QR18: PRODUCT CHANGE NOTICE

Date of Notice: (DD/MM/YYYY)	7 th May 2021	Product Change Notice Number:	USB4105 B PCN 20210607b
--	--------------------------	--------------------------------------	-------------------------

Product Identifier:	USB4105-GF-A
----------------------------	--------------

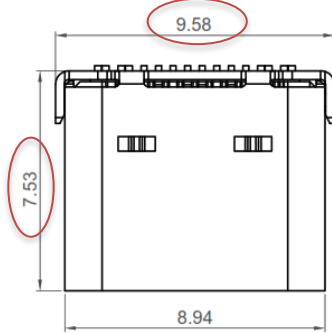
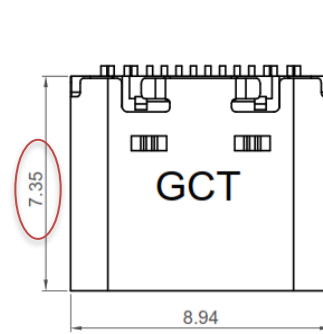
Add GCT logo to the shell.

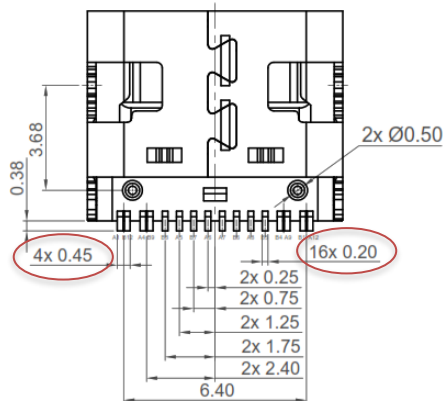
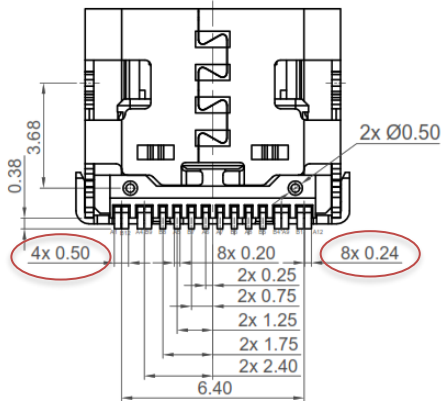
Rear flap replaced with tangs to retain the insulator, reducing the effective width from 9.58mm to 8.94mm & total length from 7.53mm to 7.35mm.

Contact widths changed from 0.24mm to 0.2mm & 0.5mm to 0.45mm.

Tolerances added to mating faces.

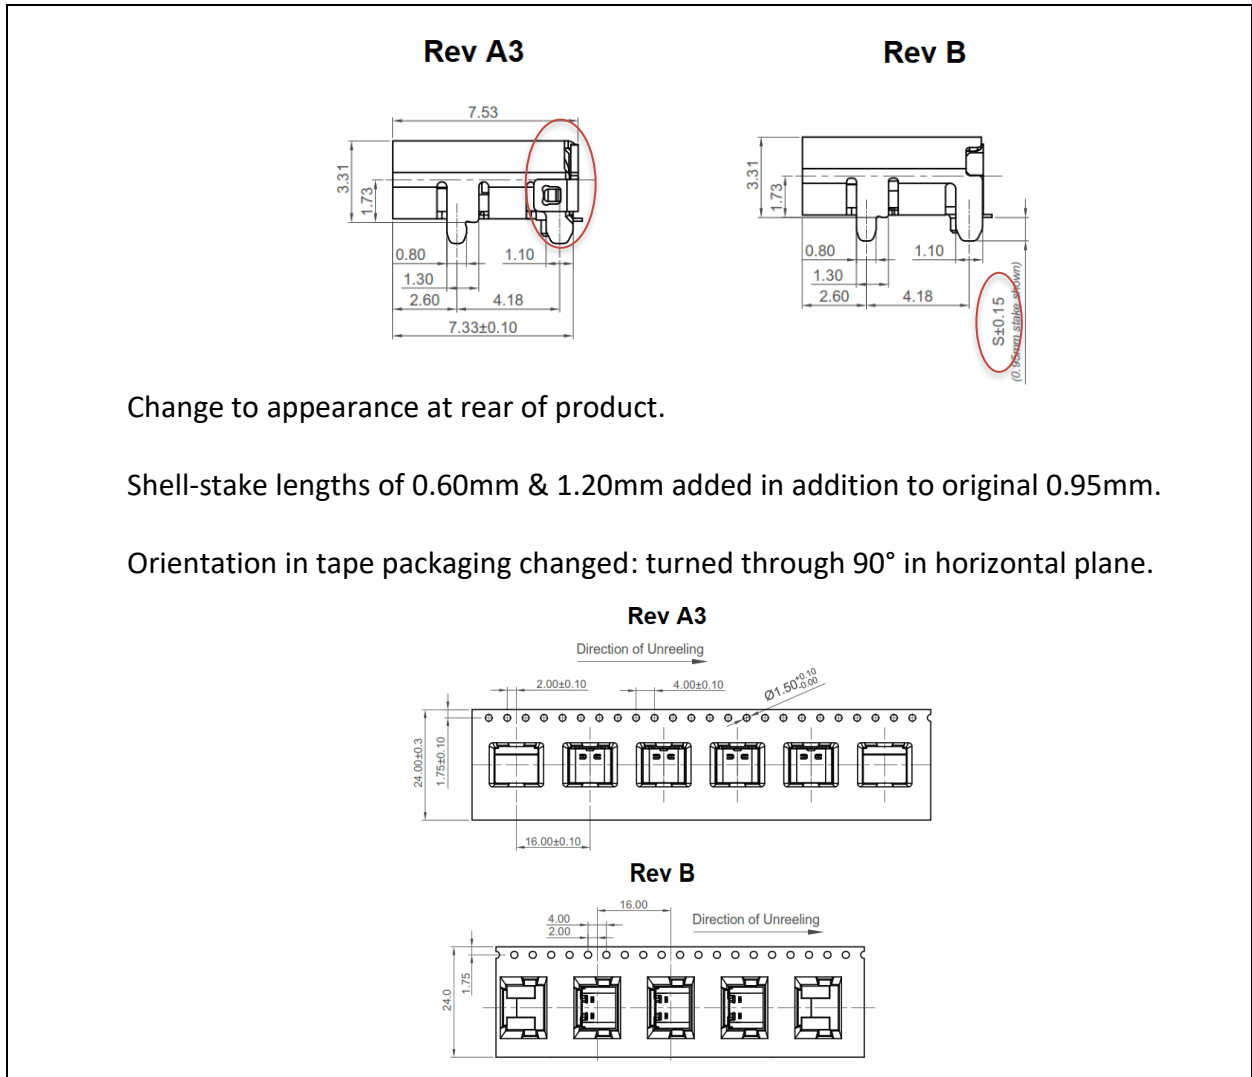
Location peg changed from 0.65mm to 0.6mm.

Change to appearance at rear of product.

Shell-stake lengths of 0.60mm & 1.20mm added in addition to original 0.95mm.
